**Table of Contents – Chapter III**

*Merrimack Station (NH0001465) Response to Comments* Page III-25 of III-227

Figure 4-1. Percent withdrawal versus total number entrained during Merrimack River entrainment studies (2006-2007) (Normandeau 2007b).

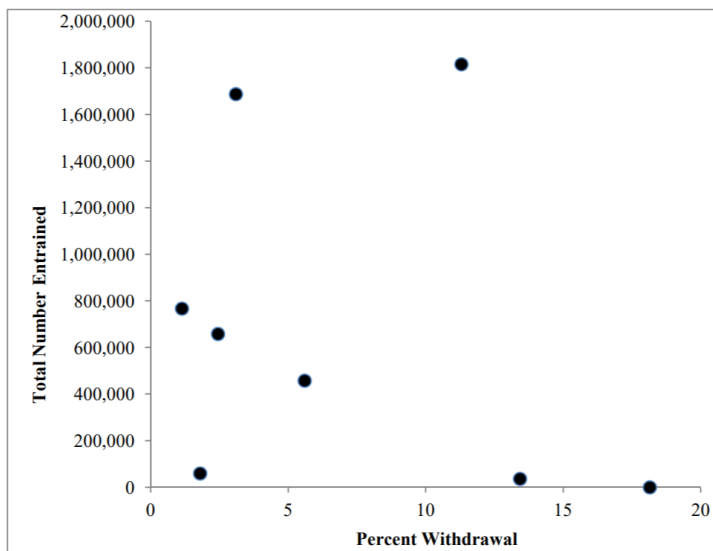
[Responding to AR-618, p. 245 Section 11.2.1a] USEPA provides no evidence for the assertion that eggs and larvae are equally distributed throughout the river. In fact, the peer-reviewed scientific literature indicates that ichthyoplankton have a very patchy spatial and temporal distribution. USEPA provides no basis for its assumption that the percent of water withdrawn for cooling can provide an estimate of the percentage of the ichthyoplankton lost to entrainment. The percentage of the water withdrawn is a factor in determining entrainment, but density of ichthyoplankton in Hooksett Pool over space and time are also important factors. Existing entrainment and withdrawal data do not support the Agency's assumption that entrainment is proportional to percent water withdrawal because the months with the greatest percentage withdrawal are also the months with the lowest ichthyoplankton densities. Figure 4-1 presents a plot of percent withdrawal on the x axis versus total entrainment on the y axis (Table 3-7; Normandeau 2007b). There is no apparent positive relationship between percent withdrawal and total monthly entrainment. In fact, a non-parametric Spearman Rank Correlation analysis indicates that there is a negative relationship (-0.41) between percent withdrawal and total monthly entrainment. The raw data are presented in Table 4-1. The months with the greatest percent withdrawal, August and September 2006, also have the lowest entrainment because ichthyoplankton are not common in Hooksett Pool during those months. The highest entrainment occurred in June of 2006 and 2007 when percent withdrawal was relatively low (June 2006), or

above average (June 2007) but entrainment was highest due to the high density of ichthyoplankton in Hooksett Pool. The conclusion to be drawn from this analysis of empirical data is that percent water withdrawal alone is not a major factor in determining entrainment at Merrimack Station. Density of ichthyoplankton in Hooksett Pool is also an important factor and the greatest percent withdrawals occur in the months when ichthyoplankton density is low. It can be seen that during May, low ichthyoplankton densities are the norm, and that the entrainment estimate for May at Unit 2 is driven by the relatively large amount of ichthyoplankton collected on the night of 31 May (Table 4-2). The data from the night of 31 May might be considered the outlier rather than the 0 counts at Unit 1, but Normandeau included all data in the analysis because there are no methodological reasons to exclude them. Empirical data should not be excluded because it appears to be “different,” but may only be excluded if there is some methodological reason that would justify the exclusion, such as abnormal field sample collection or mishap during laboratory analysis. These incidents did not occur. Therefore, USEPA’s rationale for excluding the data for Unit 1 from May, and substituting the Unit 2 data for the Unit 1 data is not valid. Normandeau’s data estimated 3.2 million larvae per year were entrained, and USEPA improperly changed this number to 3.8 million larvae entrained.
